HINCKLEY NATIONAL RAIL FREIGHT INTERCHANGE

Written Statement of Oral Case ISH3 [Appendix F - Noise Assessment Update Note]

Issue Specific Hearing 3 Response

Project	Hinckley Rail Freight Interchange		
Document Number	20231108_ISH3_003	BWB Ref	NTT2814_ISH3
Author	Lucy Elmer MSc. MIOA	Status	Issue
Checked	Mike Barrett BSc (Hons), MIOA	Revision	P03
Approved	Mike Barrett BSc (Hons), MIOA	Date	14/11/2023

Figure 1: Daytime noise levels from rail traffic, dB $L_{Aeq,16h}$

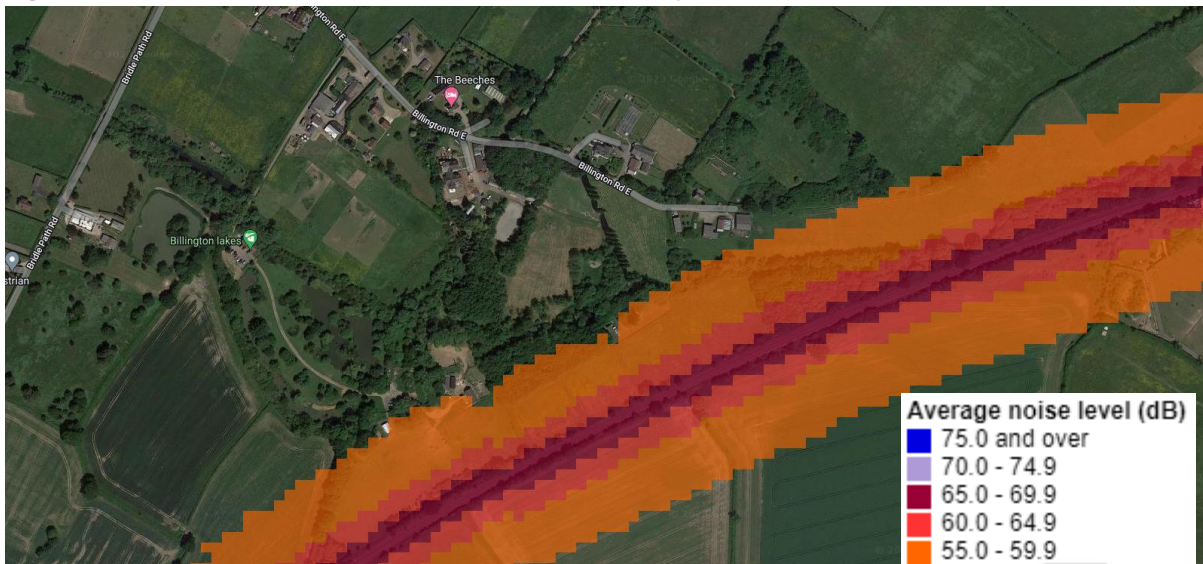
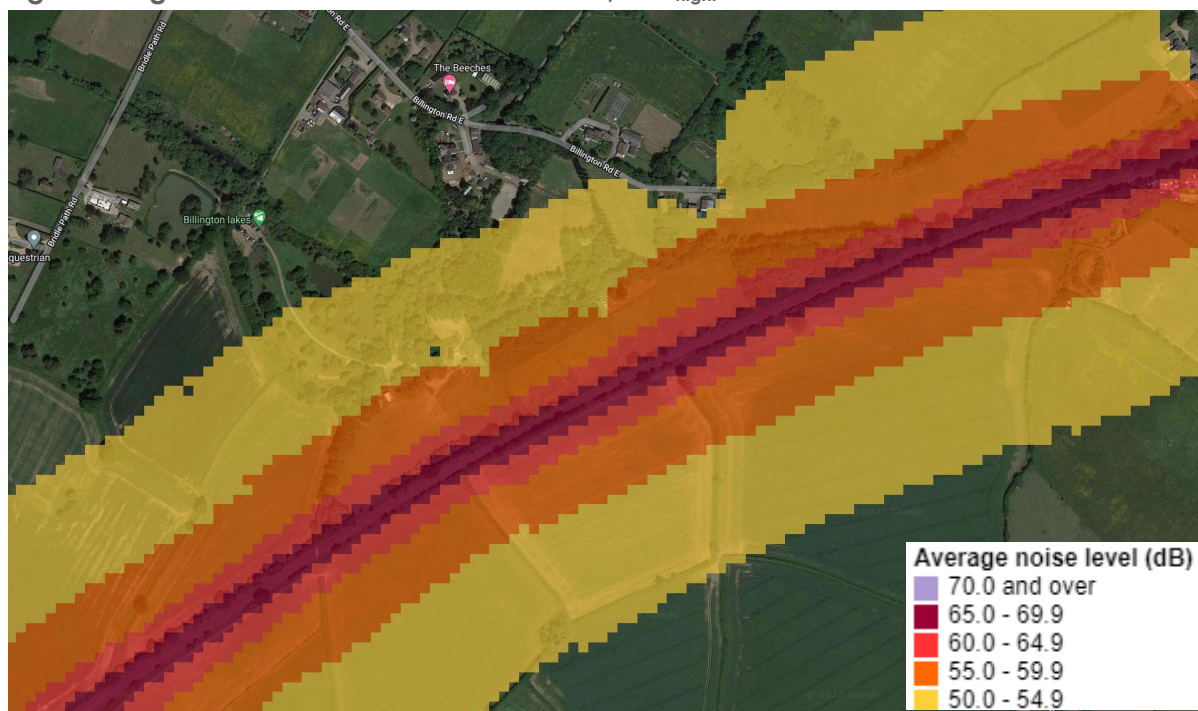
During ISH3, a query was raised on whether the ambient $L_{Aeq,T}$ noise levels measured at NMP4 are representative of the existing ambient $L_{Aeq,T}$ noise levels at NSRs located to the north of the rail line off Billington Road East, which are located further away from the rail line to NMP4.

To provide some further context to this, the latest available DEFRA noise mapping data for the rail line, and noise modelling outputs from baseline traffic data for the year 2019 have been considered.

The DEFRA noise mapping for the rail line for the daytime and night-time periods is shown below in Figures 1 and 2. The noise level is calculated at 4m in height.

As the 55 – 59.9 dB $L_{Aeq,T}$ contour for the daytime and night-time periods are very similar in location, it is reasonable to assume that the 50.0 – 54.9 dB $L_{Aeq,T}$ contour would also be similar.
